INNER WEST COUNCIL

DEVELOPMENT ASSESSMENT REPORT

Application No.	D/2019/202
Address	55 Church Street, LILYFIELD NSW 2040
Proposal	Demolition of existing dwelling-house and construction of 2X2 storey semi-detached dwellings with parking spaces and associated works, including landscaping and tree removal, fencing works, and Torrens title subdivision into 2 lots.
Date of Lodgement	4 June 2019
Applicant	T Polvere
Owner	Velopo Nominees Pty Ltd
Number of Submissions	4 objections
Value of works	\$900,000
Reason for determination at Planning Panel	Clause 4.6 variation exceeds officer delegation
Main Issues	Lot Size, Solar Access, Amenity Impacts, Site Layout and Building Design, Streetscape Appearance
Recommendation	Refusal
Attachment A	Draft conditions (if not refused)
Attachment B	Proposed Plans

Figure 6: Existing pattern of development. The blue lines indicate ground floor BLZ.

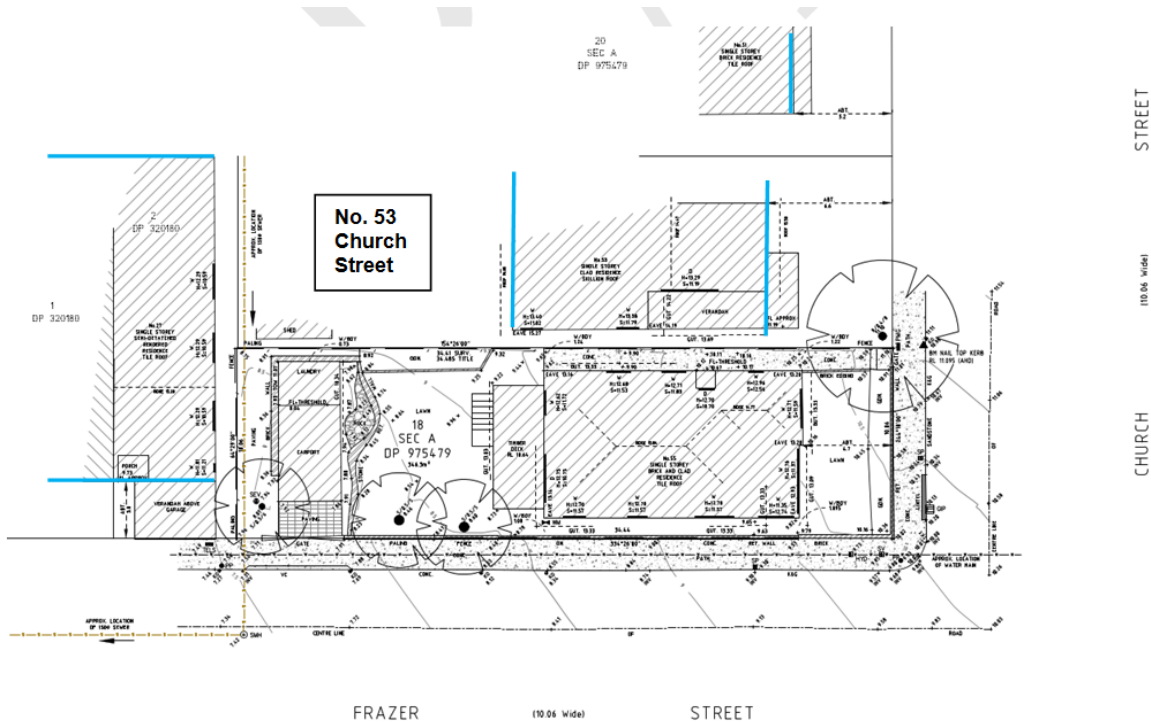
Control C5 requires the BLZ of a corner site to be determined by the location of the building on the adjacent property that most resembles the orientation, frontage width and site layout of the subject site. The single storey dwelling at 53 Church Street has a front setback of 6.6m and rear setback of 14.4m. In this instance, the proposal varies the ground floor BLZ with front and rear setbacks of 3.2m, and seeks to establish a new first floor BLZ with front and rear setbacks of 3.2m.

Whilst Control C6 enables a variation to the BLZ, it is considered that the applicant has not satisfactorily demonstrated that the proposed building is consistent with the pattern of development in the immediate locality (usually taken as the same street) and that:

- The proposed new dwellings will establish a first floor building location zone that results in adverse amenity impacts upon the surrounding properties in terms of visual bulk;
- The proposal does not comply with Council's building location zone, wall height and building envelope controls;
- The proposal will not provide a compatible area of private open space and outdoor recreation with an acceptable level of solar access for the occupants;
- The proposal is not considered to be compatible with the scale and character of surrounding development.
